Process Sheet

Customer : CU-DAR001 Dart Helicopters Services	Drawing Name : HELI UTILITY BASKET LH/RH 350/355
Job Number : 37551	
Estimate Number : 10208	
P.O. Number :	Part Number : D350607043
This Issue : 2/20/2008 S.O. No. :	Drawing Number : D350-607 REV F P7-9
Prsht Rev. : NC	Project Number : N/A
First Issue : / / Type : LARGE FAB ASSY	Drawing Revision : F
Previous Run : 37513	Material :
Written By :	Due Date : 3/20/2008 Qty: 1 Um: Each
Checked & Approved By : <u>080221</u>	
Comment : Est Rev:E as Per DSI9318 06-01-24 JLM	
Est Rev:F ECN1068 07-12-21 DD verified by:

DART SERVICE INSTRUCTION

To reduce the possibility of damaging the finish, a **NAS1515H4** washer (2 places) has been added between the hinge plate and basket frame on the **D350-607-043/-047 Heli-Utility-Basket**.

Figure 5- Basket Replacement Parts
(D350-607-043 Heli-Utility-Basket™)

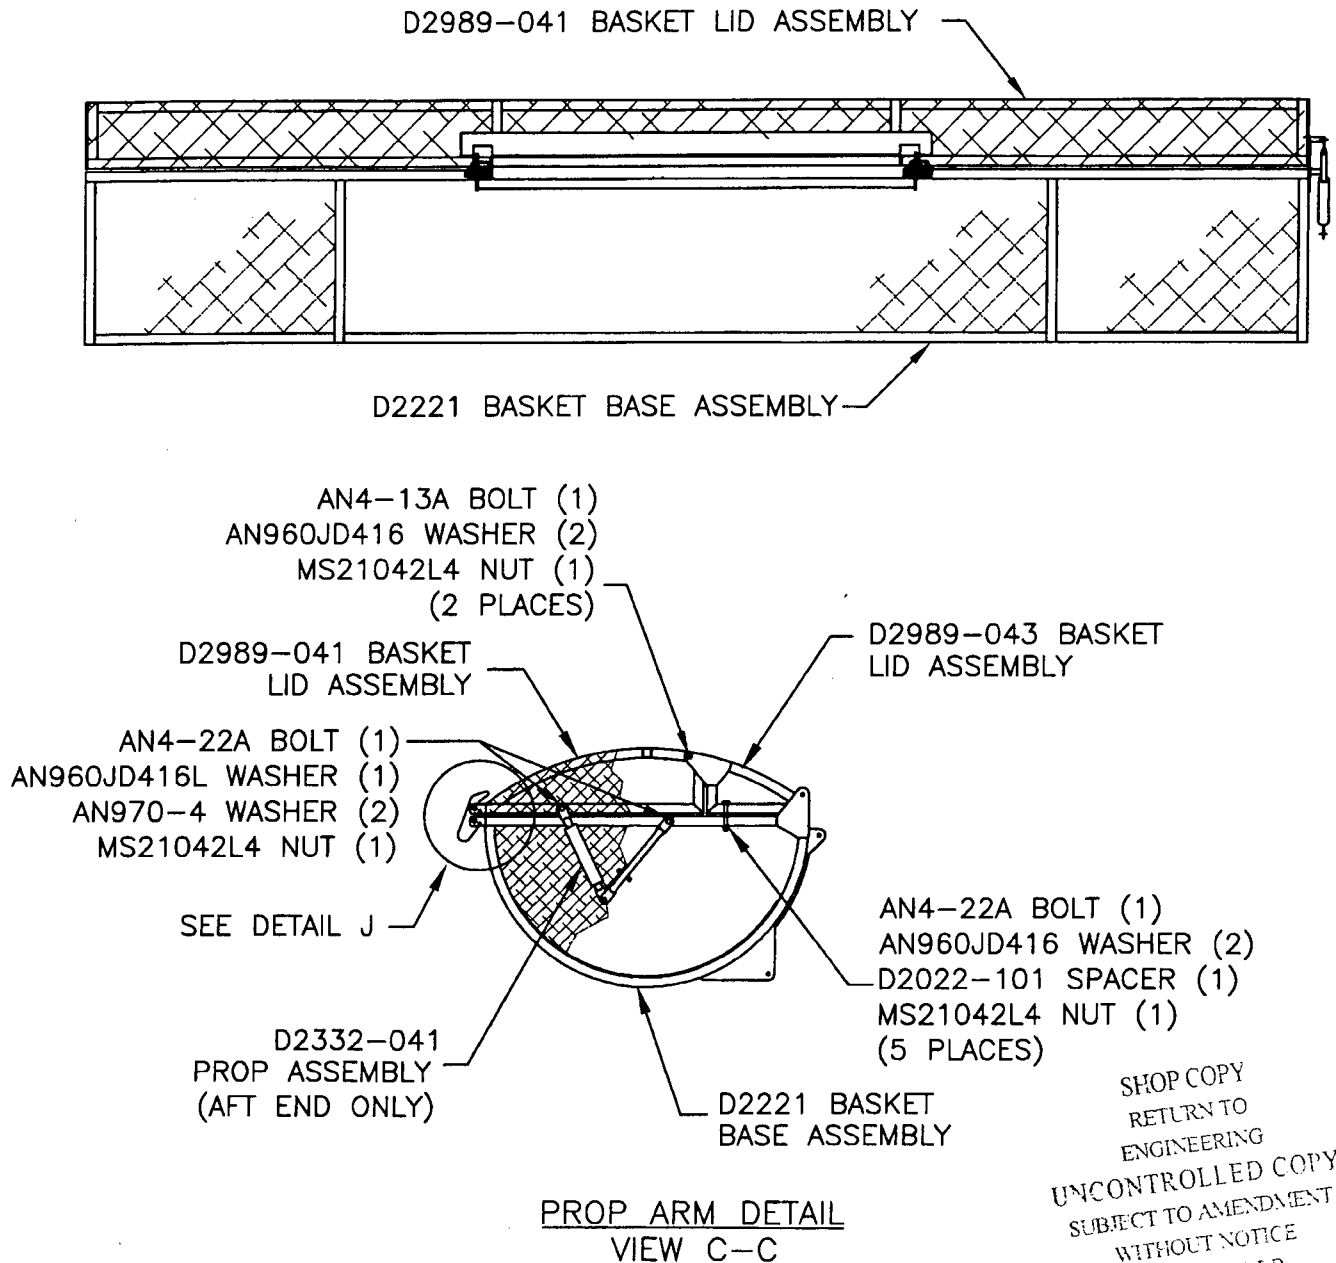
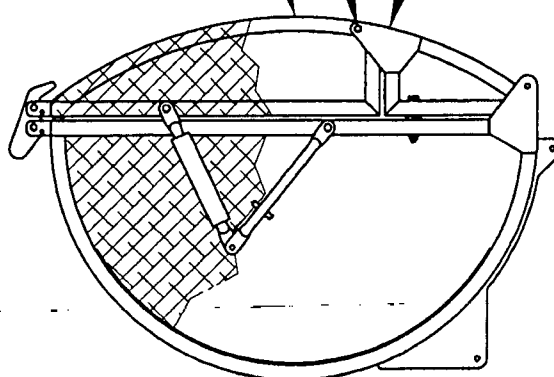
The corrected bolt stackup from Figure 5 of installation instructions D350-607 Rev. F is given below:

AN4-13A BOLT (1)
AN960JD416 WASHER (1)
HINGE PLATE (REF)
NAS1515H4 WASHER (1)
BASKET FRAME (REF)
AN960JD416 WASHER (1)
MS21042L4 NUT (1)
(2 PLACES)

DESIGN DS	DRAWN BY PH	DART AEROSPACE LTD HAWKESBURY, ONTARIO, CANADA	
CHECKED <i>[Signature]</i>	APPROVED <i>[Signature]</i>	DRAWING NO. D2989	REV. B SHEET 1 OF 3
DATE 05.06.07		TITLE BASKET LID ASSEMBLY	SCALE NTS
A	00.10.27	NEW ISSUE	
B	05.06.07	ADD SHIM UNDER HINGES, UPDATE LID DIMENSIONS

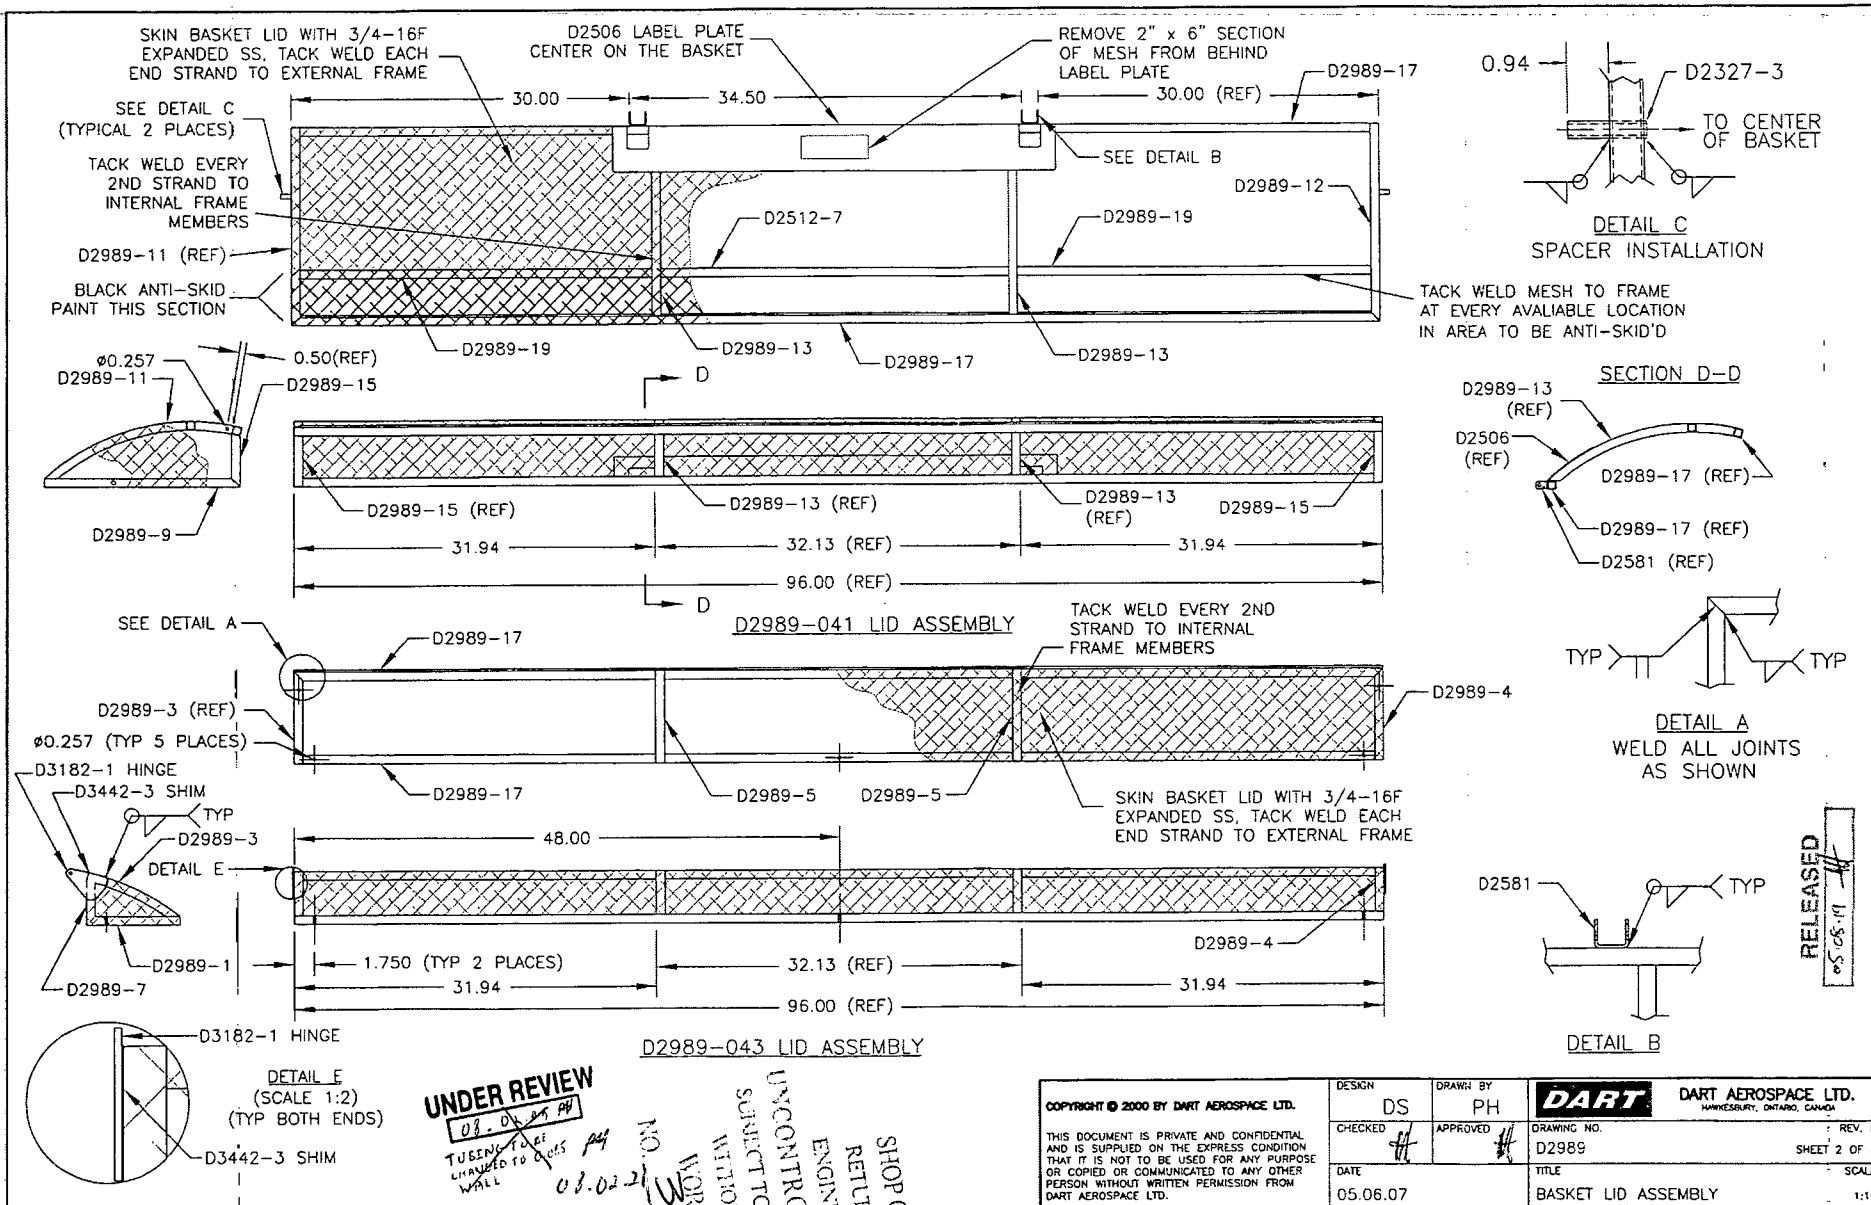
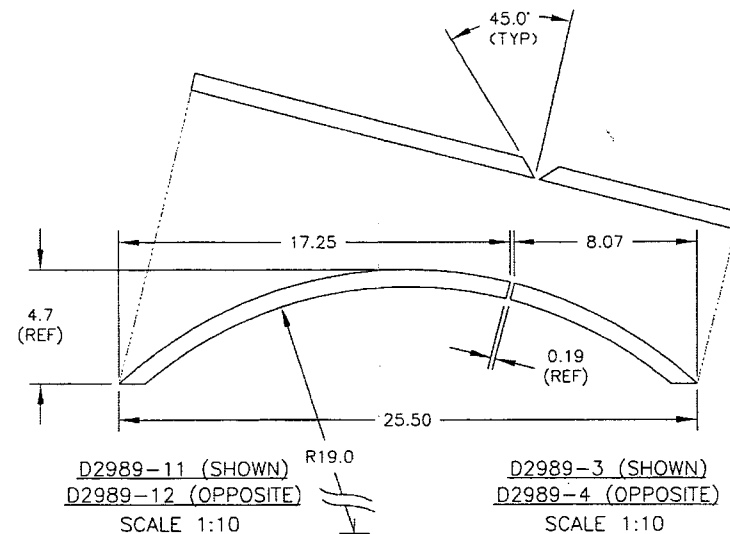
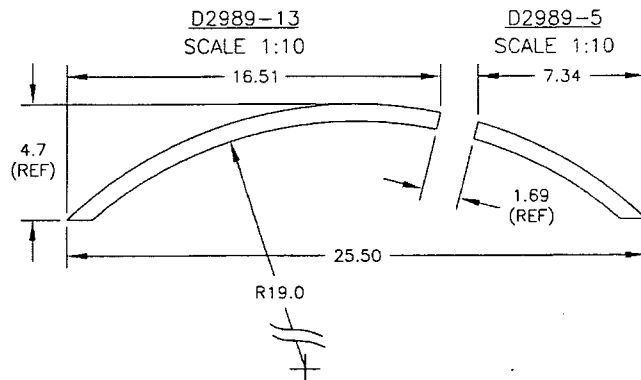
TUBING TO BE
CHANGED TO 0.065
WALL *[Signature]*
01.02.21

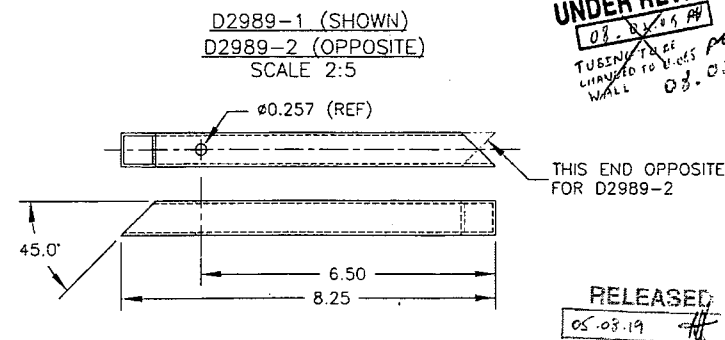
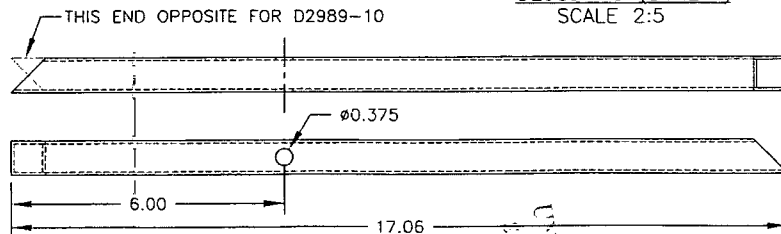
UNDER REVIEW
08.08.08 PH
TUBING TO BE
CHANGED TO 1/8" O.D.
WALL 08.02.21

DESIGN DS	DRAWN BY PH	DART AEROSPACE LTD HAWKESBURY, ONTARIO, CANADA	
CHECKED <i>[Signature]</i>	APPROVED <i>[Signature]</i>	DRAWING NO. D2989	REV. B SHEET 1 OF 3
DATE 05.06.07		TITLE BASKET LID ASSEMBLY SCALE NTS	
A	00.10.27	NEW ISSUE	
B	05.06.07	ADD SHIM UNDER HINGES, UPDATE LID DIMENSIONS

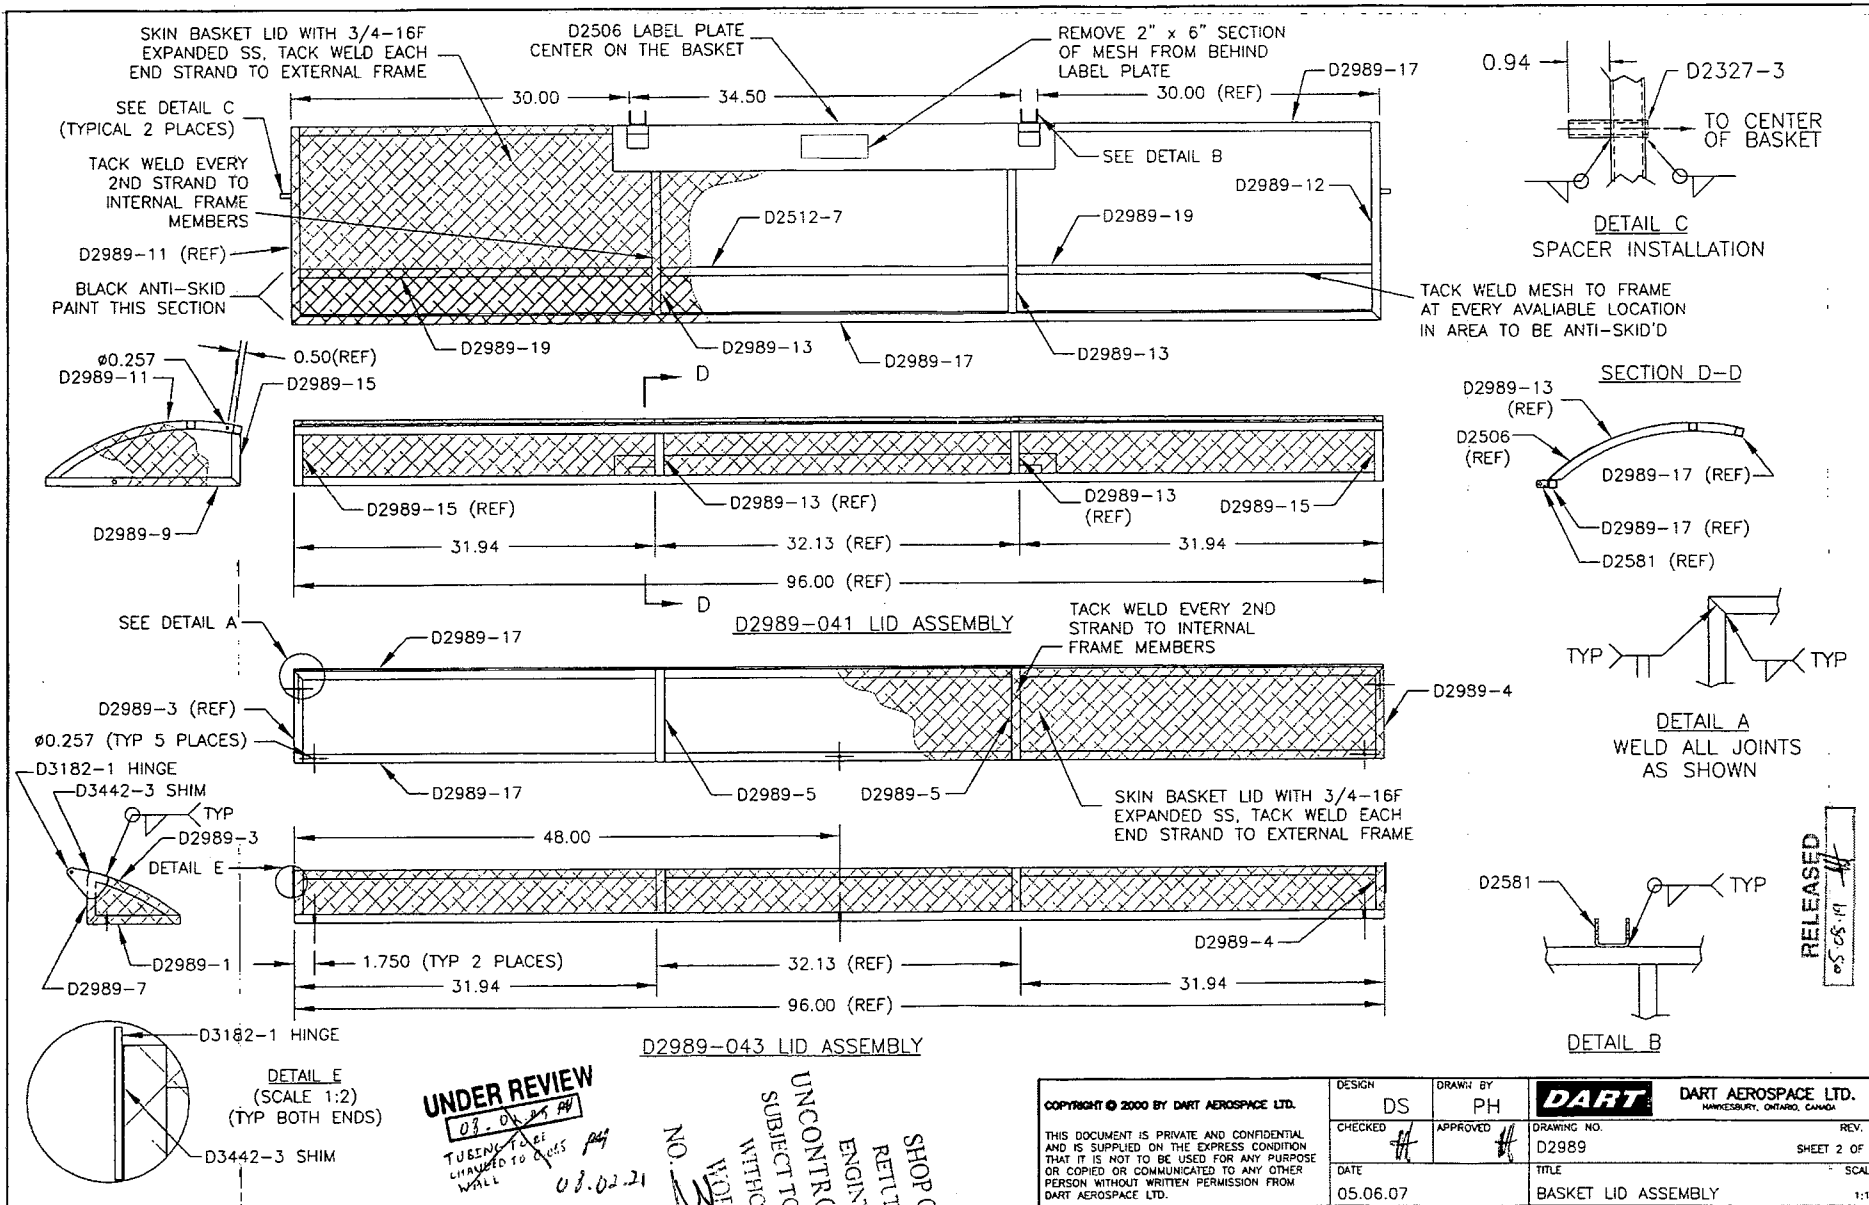
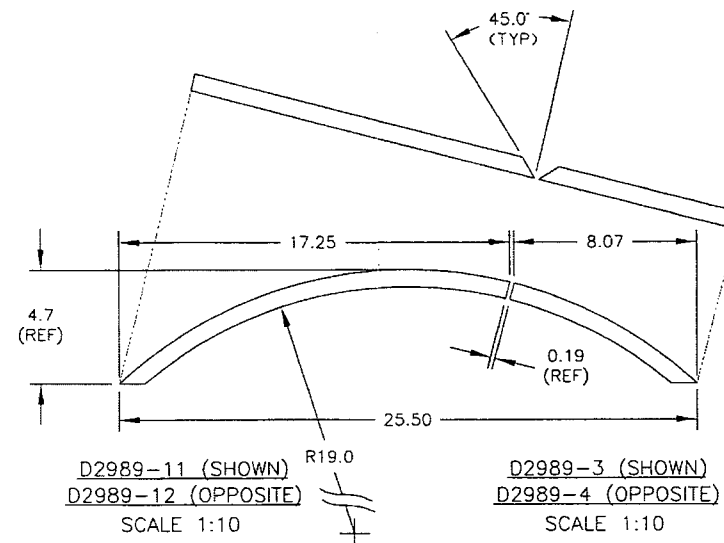
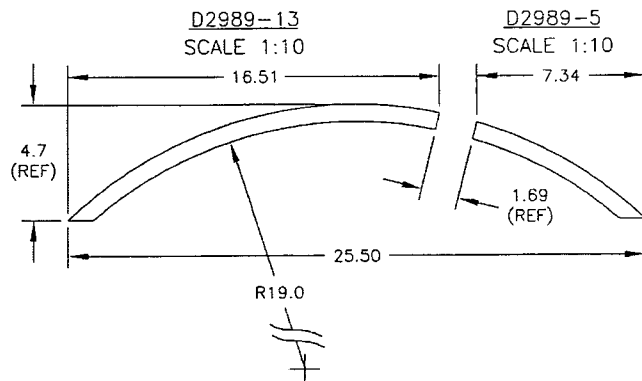
TUBING TO BE
CHANGED TO 0.065
WALL *[Signature]*
03.02.21

D2989-1 (SHOWN)
D2989-2 (OPPOSITE)
SCALE 2:5

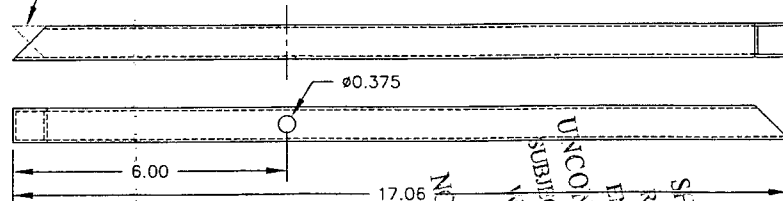
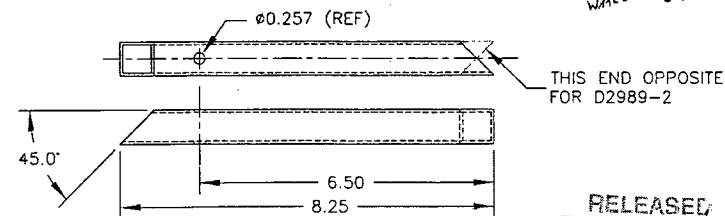
UNDER REVIEW
08.03.05 PH
TUBING TO BE
CHANGED TO 0.065
WALL 08.03.21

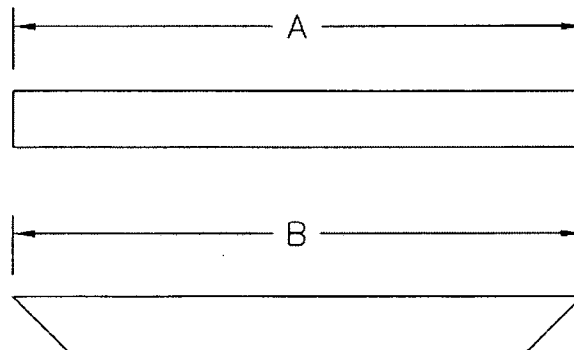
08.02.05 PH
TUBING TO BE
CHANGED TO 0.065
WALL COPY

DESIGN	BW	DRAWN BY	PH	DART AEROSPACE LTD
CHECKED		APPROVED		HAWKESBURY, ONTARIO, CANADA
DATE	05.06.07	DRAWING NO.	D2221	REV. F
		TITLE	BASKET BASE ASSEMBLY (350)	SHEET 2 OF 3
				SCALE 1:20

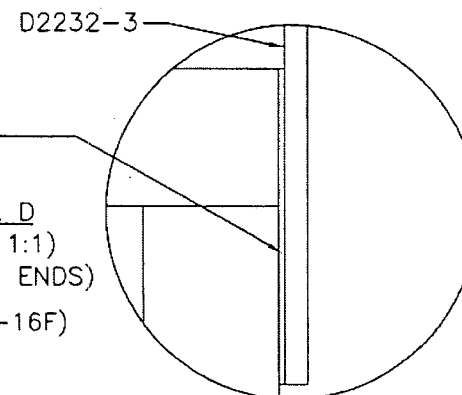
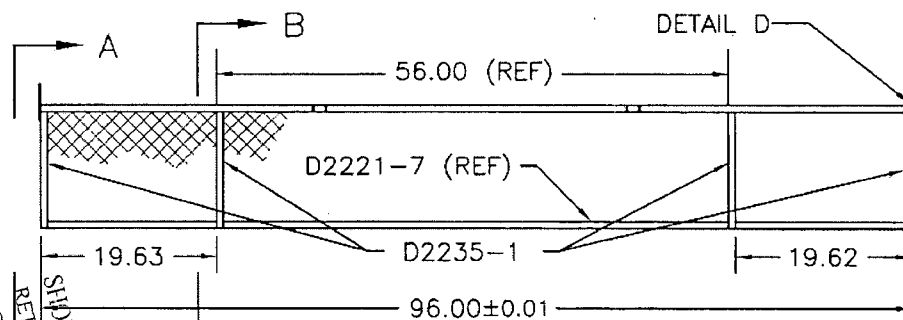
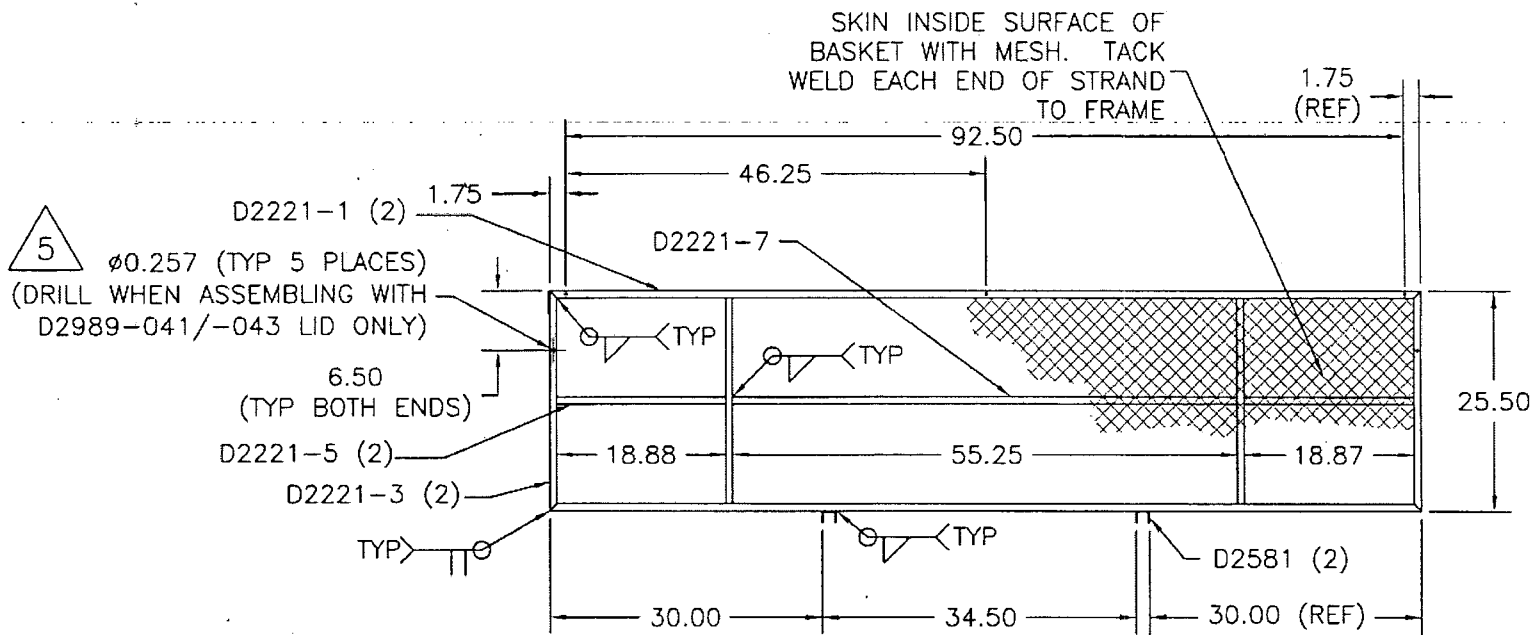
UNDER REVIEW
03.02.05 PH
TUBING TO BE
CHANGED TO 0.065
WALL PH
03.02.21
